environmental statement

related to the proposed

CRYSTAL RIVER UNIT 3

DOCKET NO. 50-302

FIGURE 2.5 TROPHIC PATHWAYS IN THE MARSHLAND ECOSYSTEM

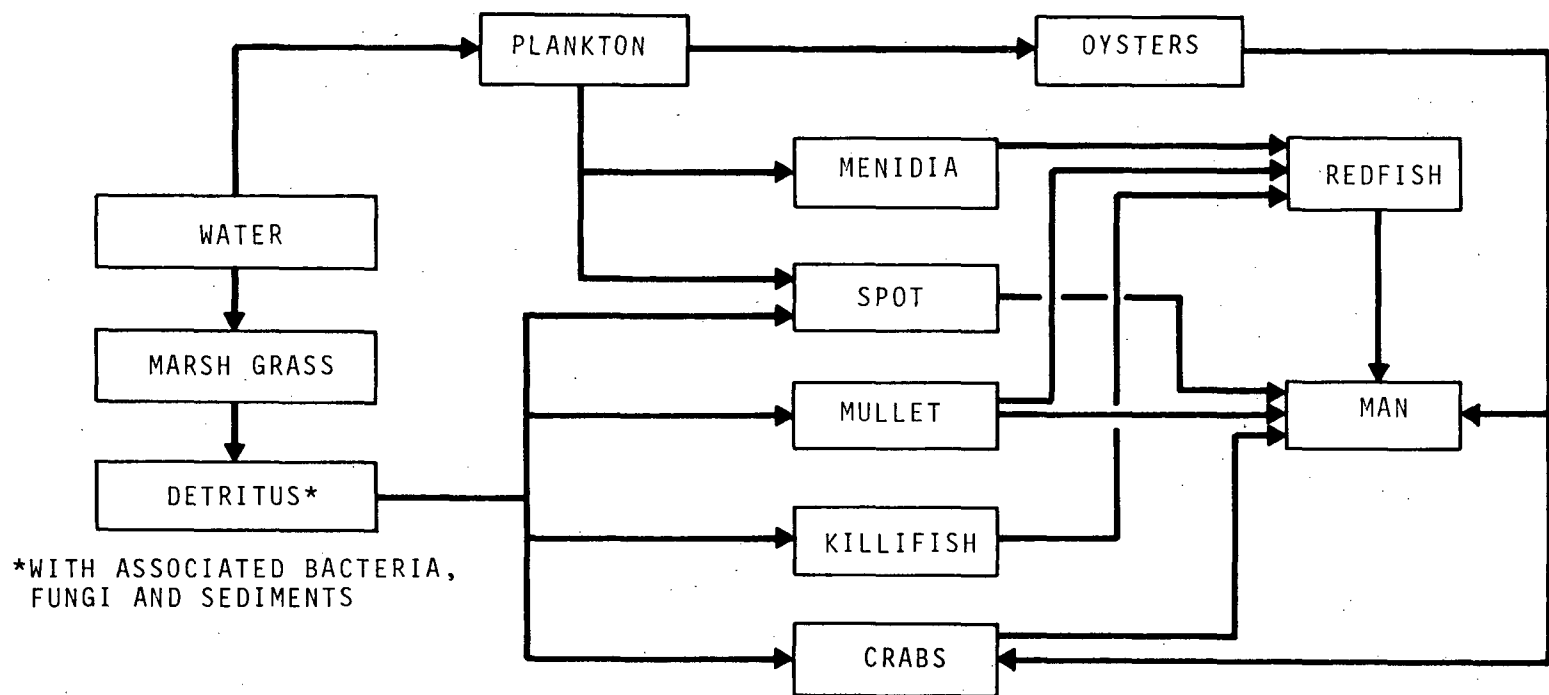
(4) Page 2-26. In Figure 2.5 the trophic pathways as presented are misleading; for example, oysters generally obtain their energy from filter feeding of detritus, rather than phytoplankton. Killifishes are thought to feed upon larval insects, primarily mosquito larvae, and Leiostomus xanthurus are not detritus feeders. Although many crabs are detritus feeders, those of importance to man, as Callinectes sapidus, are generally considered to be predators or scavengers. Table 2.6 has similar deficiencies. Inclusion of the category "bottom dwelling invertebrates," such as mollusks, annelids and crustaceans, as the primary consumer organisms of detritus is suggested.
